Denim Expert Ltd.

Plot #96-100, Sector #3, Kepz, North Patenga, Chittagong.
(22.27350E, 91.79150N)

20 May 2014

Off-cut material store

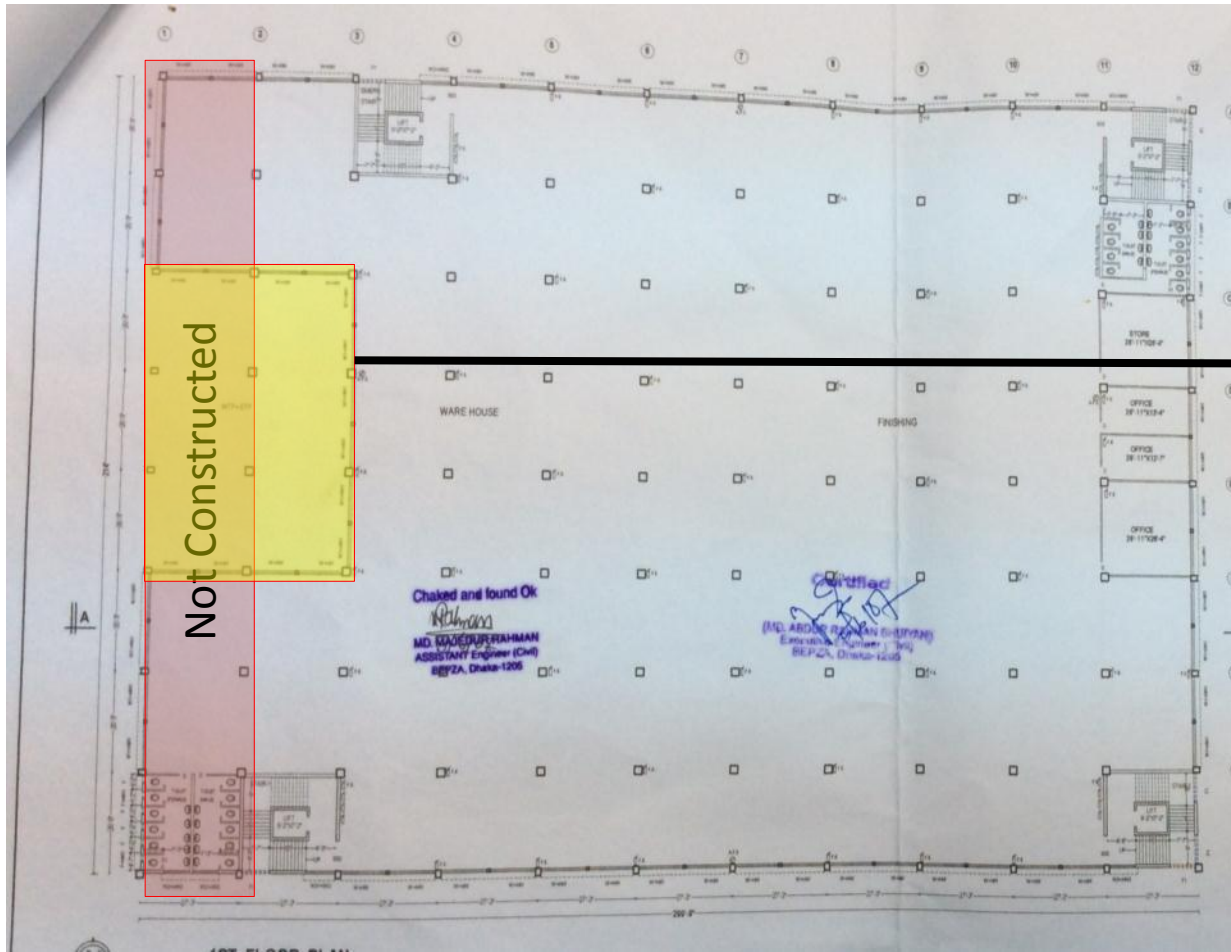
Non-Engineered Lightweight Roof Structures

Apparently Non engineered light weight roof structures

Inconsistencies noted on Structural and Permit drawing

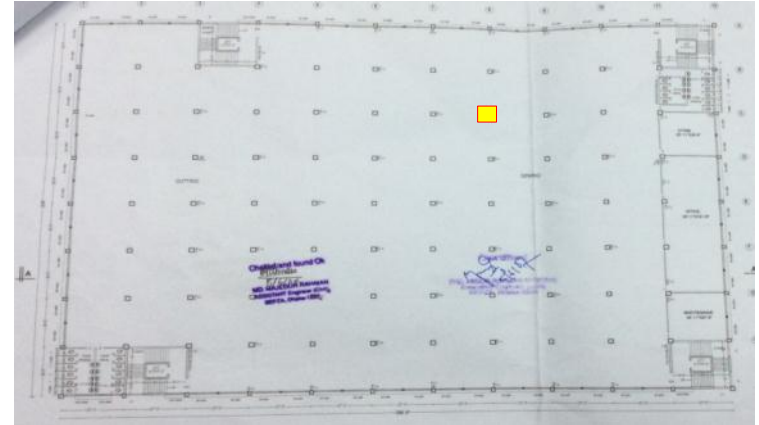
Extra bay on permit drawing does not match as built construction or structural drawings

EPT located in separated building to main factory building

Structural Drawings:
Internal and external columns 840mm x 840mm on structural drawings. Measured as built columns (including finishes) typically <790mm. (observed finishes 20m)
